**Benton County Planning Board**

**COMMERCIAL/INDUSTRIAL LARGE SCALE DEVELOPMENT:  
PLANNER'S TECHNICAL REPORT**

**14101 East Hwy 12, Rogers, AR 72756**

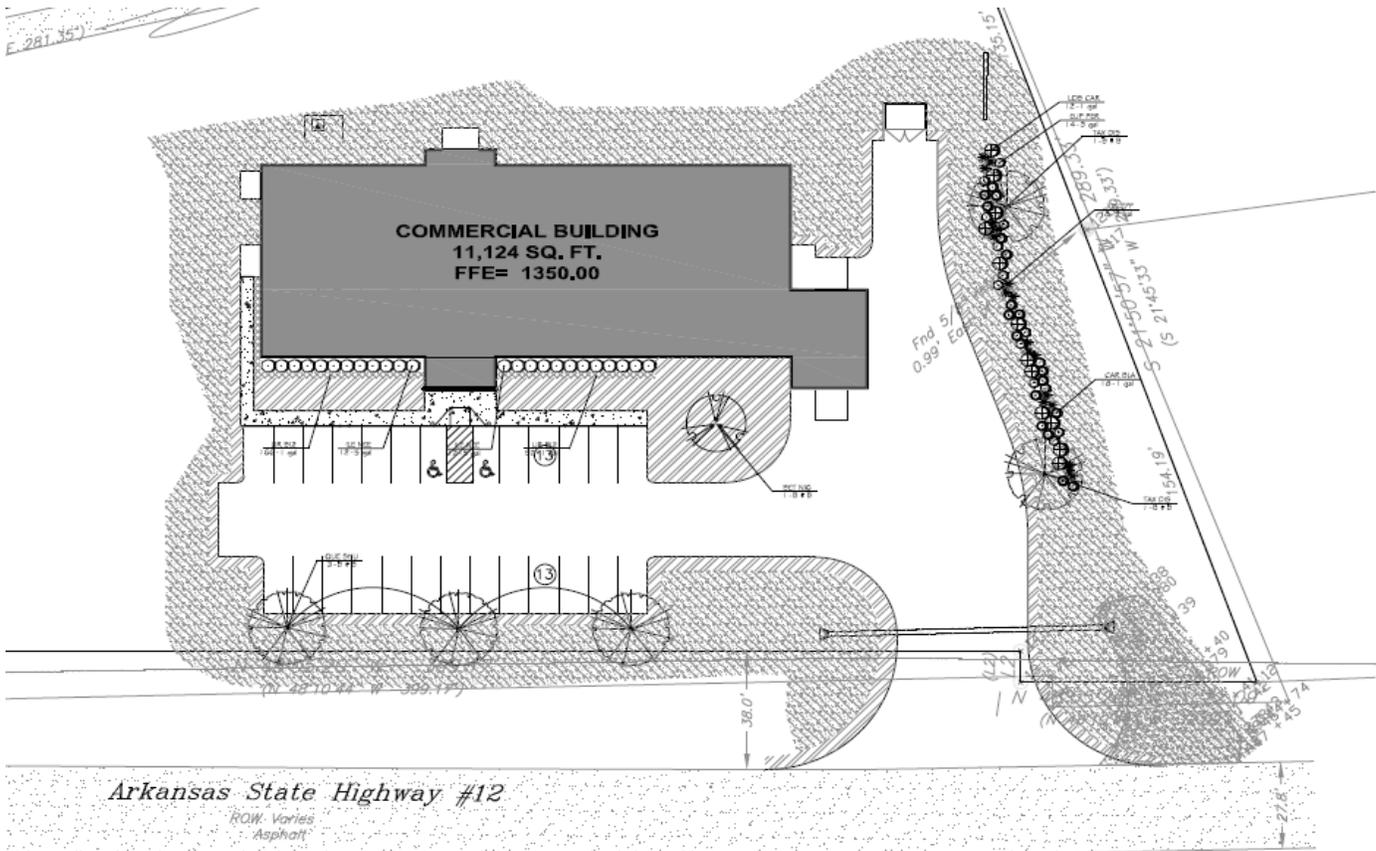
1. Length of parking space is required to be 19'. The parking space length on the submitted site plan is 18'. The parking space length should be corrected to meet Benton County standards.
2. Driveway aisle is required to be 25'. The driveway aisle on the submitted site plan is 24'. The driveway aisle should be corrected to meet Benton County standards.
3. The applicant has indicated that trucks of various sizes will be loading and unloading product components and finished product at the west side of the building. The applicant should indicate the location and dimensions of the proposed loading zones on the site plan. The loading zones should be marked with striping.
4. The applicant should indicate automotive and truck traffic flow on the site plan.
5. Any additional parking areas located on the property should be detailed on the site plan
